SERVICE LETTER

SUBJECT: PRATT & WHITNEY CANADA SERVICE BULLETIN NO: 14233

PRATT & WHITNEY CANADA
SERVICE BULLETIN

TURBOPROP ENGINE
SEALING PLATES AND SPACER - REPLACEMENT OF

Firewall Plate Seals - Replacement of
Figure 1

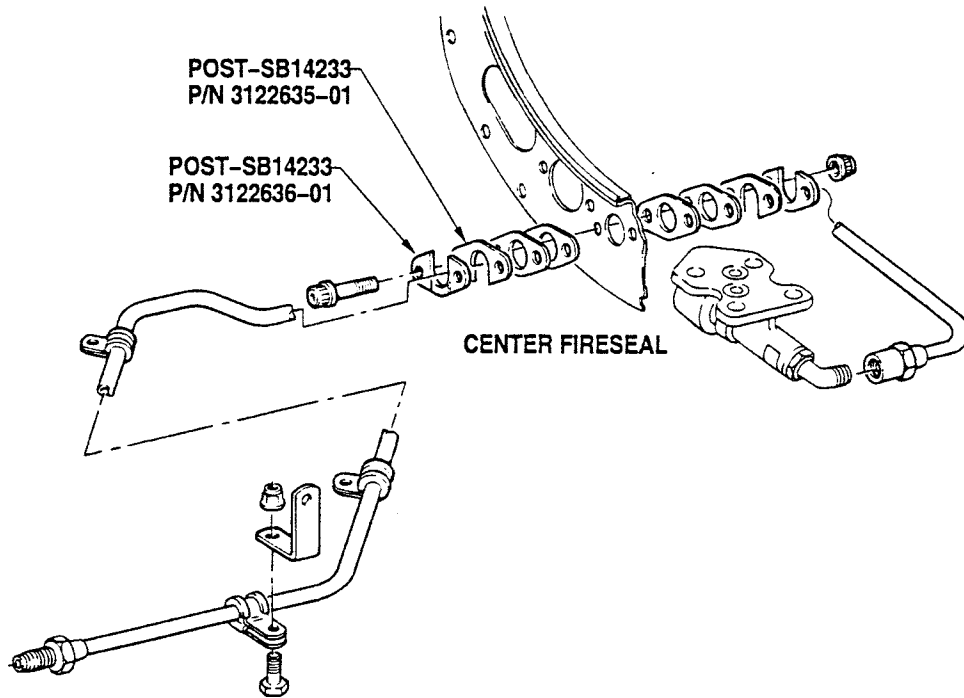
Fretting has occurred on the primary fuel tube at the center firewall section.

It is possible that there is not enough clearance between the firewall inner/outer sealing plates in relation to the primary fuel tube tolerance envelope. This condition can cause fretting of the tube.

New sealing plates with larger cut-out are introduced to make sure there is sufficient clearance for the primary fuel tube to go through the center of the center fireseal holes. For the PT6A-67B, because the clamping arrangement is different, a thinner spacer is required at the No.2 bearing oil scavenge tube.

Replace the sealing plates with similar plates that have larger cut-outs and, for the PT6A-67B only, one flat spacer is also replaced with a sleeve spacer at the No. 2 bearing oil scavenge tube.

(1) Remove two old inner firewall plate seals P/N 3019384 and two outer firewall plate seals P/N 3019385.

(2) Install new inner firewall plate seals P/N 3122635-01 and two new outer firewall plate seals P/N 3122636-01.

NOTE: Make sure that the fuel lines are positioned at the center of the plates when completely installed.

(3) Inspect fuel pressure tube assembly P/N 3037677 at the firewall plate seal for fretting wear.

NOTE: Fretting in excess of 0.008 inch. will require the fuel pressure tube assembly to be replaced, and the fuel pressure tube assembly can be ordered from P&WC on a "No Charge P.O." referencing SPA No. A95048R1.
